This SI 142/90 contains information about modifications that have to be done on the D820-48. This set of modifications has been named Version 1.0 .

3. MODIFICATION INSTRUCTIONS

Werkstoff: DIN Bez Abmessung	Norm-Nr DIN Bez Abmessung		Oberfläche: Beh	Änderung
	Zugehörige Unterlagen PL, BV 640	Freimaßtoleranz 1,3:1		
Ersatz für	Ersetzt durch		Kopie für	Nummer 4.862.661-20
STUDER REGENSDORF ZÜRICH	CUE-MODULATOR ESE			Datum 26.6.90

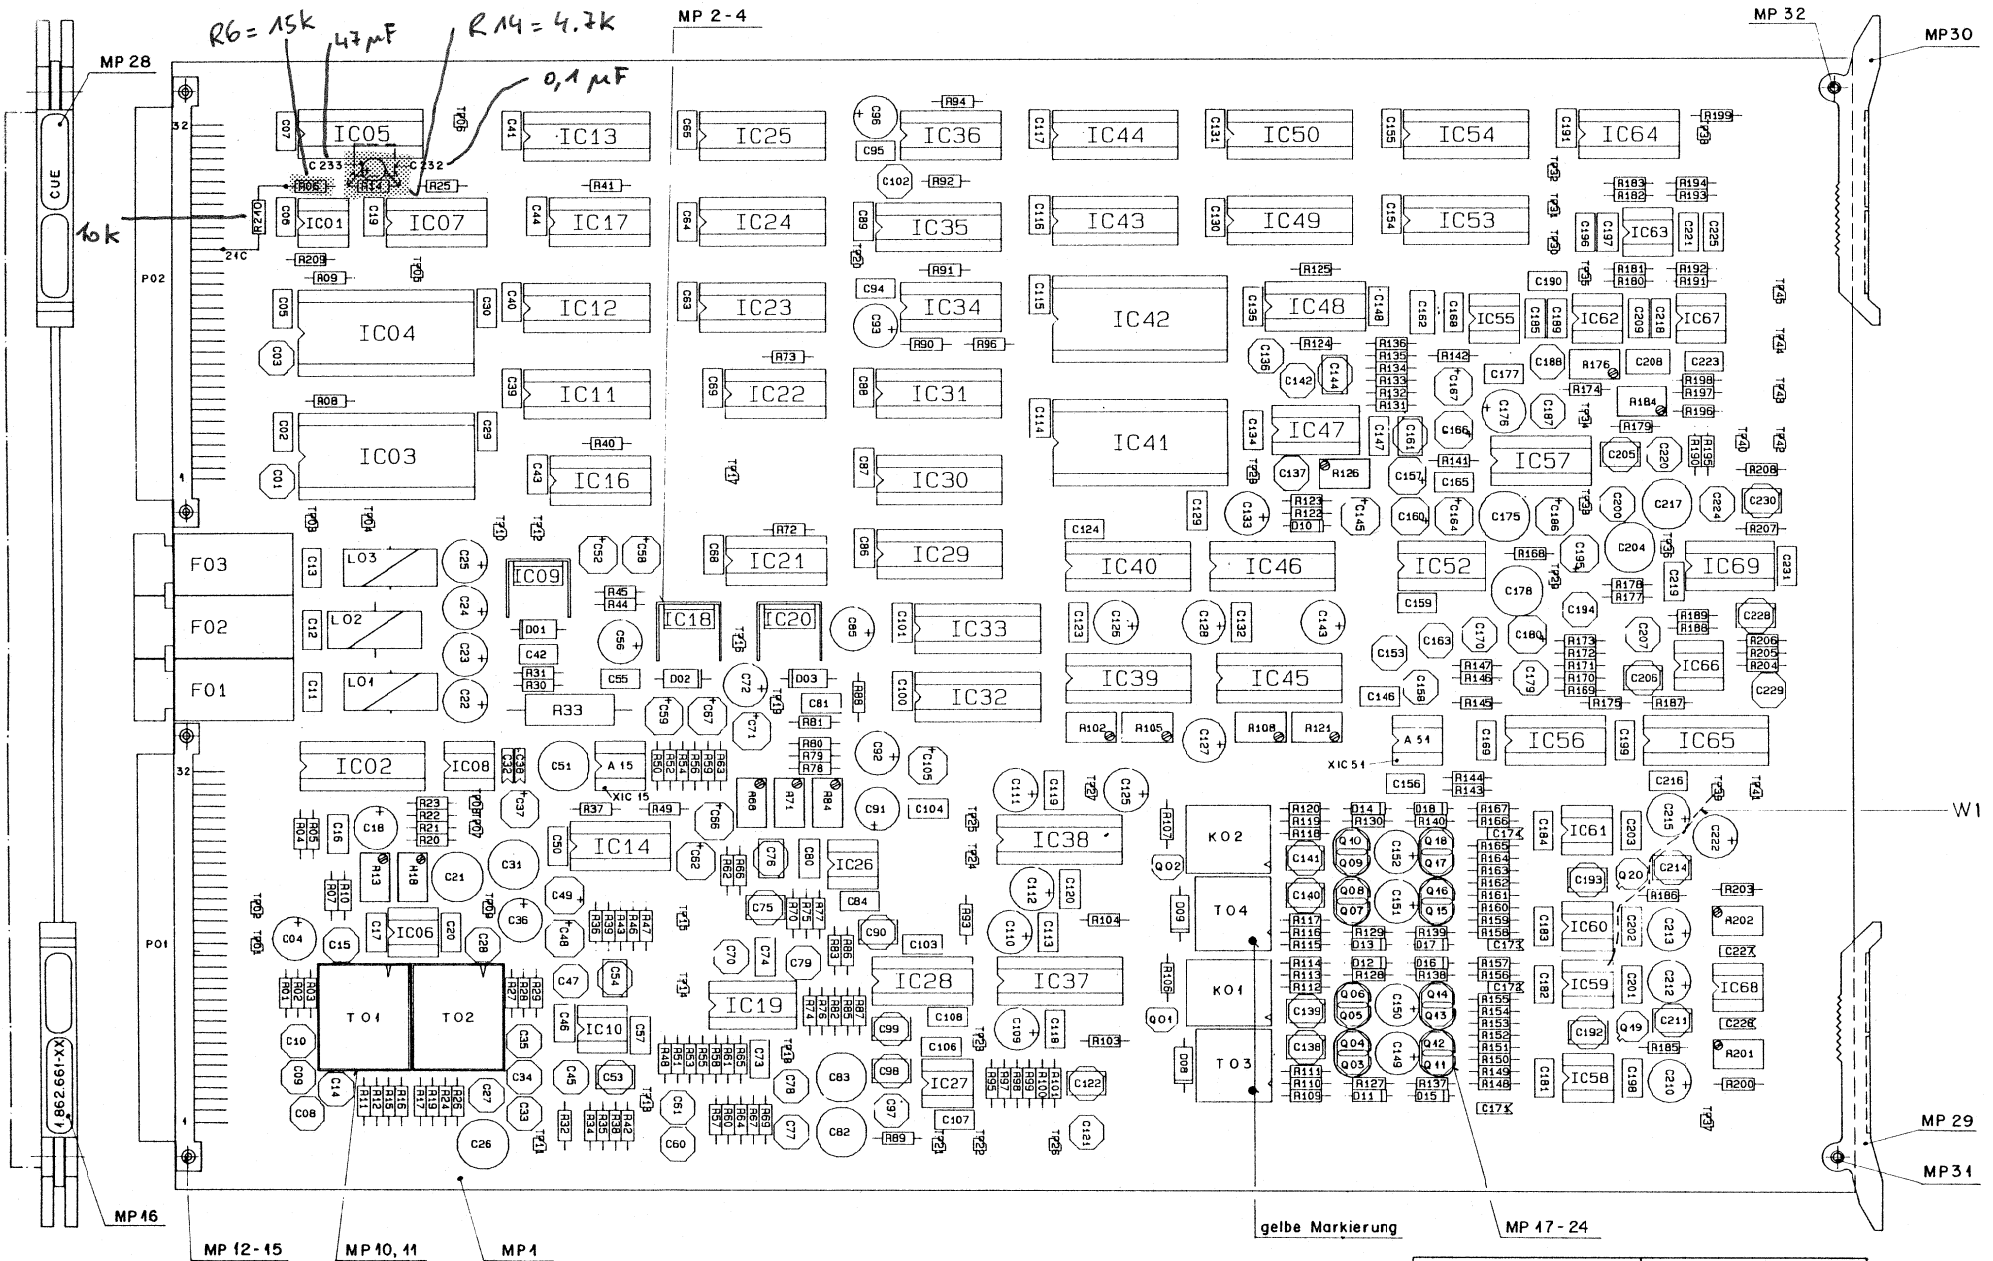
R 6 10k becomes 15k (57.11.3153),
R 14 3.9k becomes 4.7k (57.11.3472),
Add C 233 47 uF (59.22.3470) in parallel to R 14.

Add a resistor R 210 10k (57.11.3103) between Pin 6 and +5V
(C 06) of IC 01.
Add a capacitor C 232 0.1 uF (59.06.0104) in parallel to R14
(see schematic).

C 232 auf Lötseite
